ASSESSMENT REPORT

HUNTLEE NEW TOWN STAGE 1 MP 10_0137 MOD 6

Figure 3: Proposed Subdivision – Town Centre (source: Proponent's application)

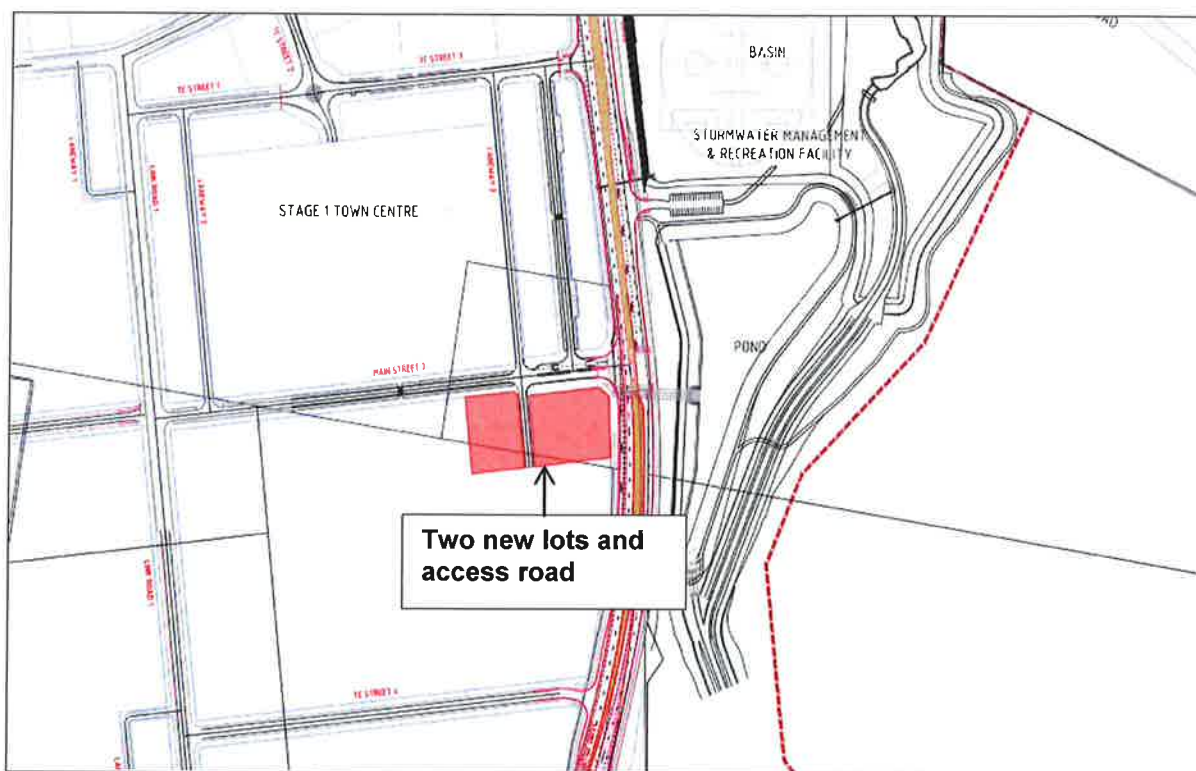
<i>Issue</i>	<i>Consideration</i>	<i>Recommendation</i>
<i>Subdivision Layout</i>	• The proposed modification seeks approval to subdivide a super lot within the Town Centre into two smaller commercial lots and provide a new access lane. The Department considers the proposed subdivision is acceptable because: – it is a minor change, which would allow the site to be occupied by future commercial tenants, consistent with the approved use of the Town Centre site; and – it is consistent with the <i>Huntlee Development Control Plan 2013</i> (HDCP 2013) in terms of the layout of the retail core and the road network hierarchy (refer to Appendix A). • The proposed modification also seeks approval to include one additional residential lot in sub-stage 4. The Department considers the proposed subdivision is acceptable because: – it would result in a total of 1,473 lots (within Stage 1), which is the same as originally approved; – It would not result in any additional traffic impacts beyond those already assessed and approved; and – it is consistent with HDCP 2013 in terms of the minimum lot dimensions and would not compromise compliance of the adjoining	Condition A2 is amended to incorporate the modified subdivision layout in Stage 1 of the Huntlee Masterplan.

Figure 5: Traffic Infrastructure Upgrade – Stage 1 (Source: Proponent's Modification request)

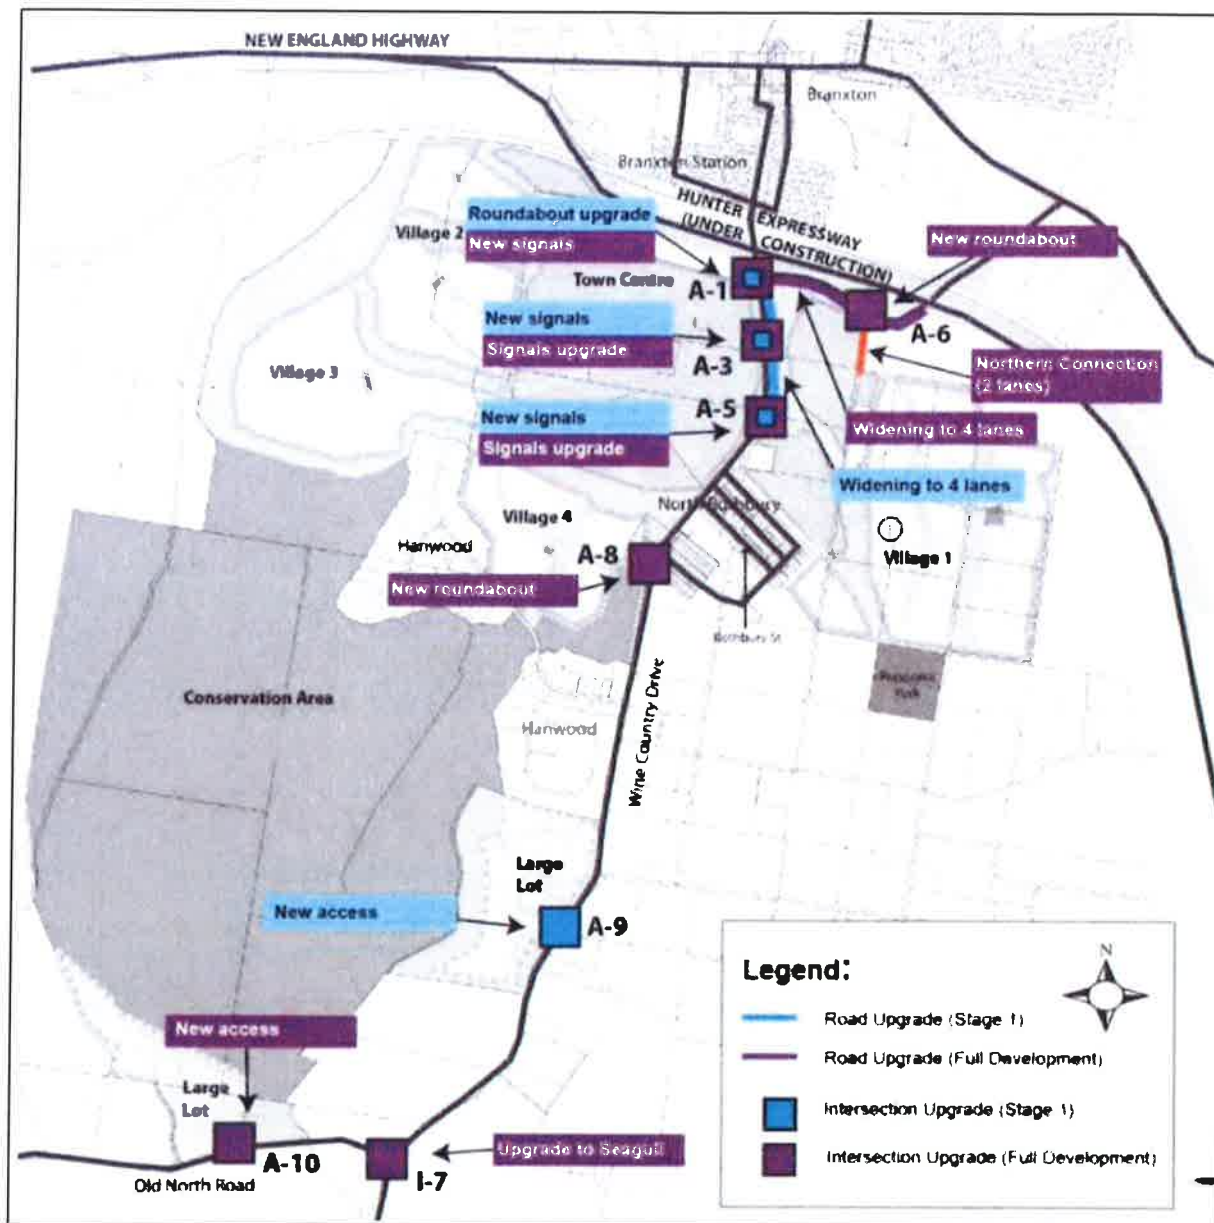
RMS initially raised concerns with the traffic analysis and modelling undertaken by the Proponent. However, following further consideration of those issues, RMS raises no further concern, subject to specific changes to the road infrastructure upgrade requirements.

Issue	Consideration	Recommendation
	lots with the lot width and area controls.	
	- The Department considers the subdivision layout and design are consistent with the aims and objectives of HDCP 2013, and there would be no additional environmental impacts on the surrounding area. - The Department is satisfied the proposed subdivision layout would not result in any material change to Stage 1 of the Huntlee Masterplan.	
Infrastructure Upgrades	- Condition E7 was imposed on the original approval, requiring road upgrades to be undertaken at various stages of the development, based on modelling undertaken by the Proponent and RMS recommendations. - The proposed modification seeks approval to defer the timing of the road infrastructure upgrades by adjusting the various thresholds currently nominated in Condition E7, following a review of the intersection modelling and traffic analysis. The modification as originally submitted sought to increase the lot threshold for the delivery of road infrastructure from 500 lots to 1,500 lots. - In support of the change, the Proponent submitted an Intersection and Road Upgrade Threshold Analysis Review (the Review), which provides an assessment of the infrastructure upgrades and the actual capacity (in terms of lots) that can be achieved, prior to the upgrades being required. - The Review identifies key changes that affect the timing of the upgrades since the original approval was granted in 2012. These include a decrease in the RMS standard for residential trip generation rates in regional areas and updated traffic volume data collected in March 2016, which provides a 15 per cent reduction in traffic flows since the opening of the Hunter Expressway in 2014. - The Department considers the Proponent has provided reasonable justification to support an adjustment of the threshold limits for the upgrade of road infrastructure. However, the Department raised concern that the road infrastructure upgrades would not be delivered as part of Stage 1 for 1,472 lots. - In response, the RtS included a reduced threshold of 1,000 lots to address the Department's concerns. - RMS subsequently recommended the following threshold requirements for the delivery of road upgrade works: - Wine Country Drive to be upgraded to 4-through lanes prior to 725 dwellings or 1 June 2018 (whichever occurs first); - Wine Country Drive/Hex Link Road intersection upgraded to a two lane roundabout prior to 725 dwellings or 1 June 2018; - Wine Country Drive/Main Street to be traffic signal controlled prior to construction of development west of Wine Country Drive; and - Wine Country Drive/Village Access to be traffic signal controlled prior to 1,000 dwellings. - The Proponent was consulted on the recommended thresholds and have raised no concerns. - Council also have raised no concerns regarding the proposed changes. - Subject to the recommendations provided by RMS being included in the modified Project Approval, the Department is satisfied the proposed changes to the lot thresholds and road infrastructure upgrade works can be supported.	Condition E7 is amended to reflect the adjusted thresholds for road infrastructure upgrades as recommended by RMS.
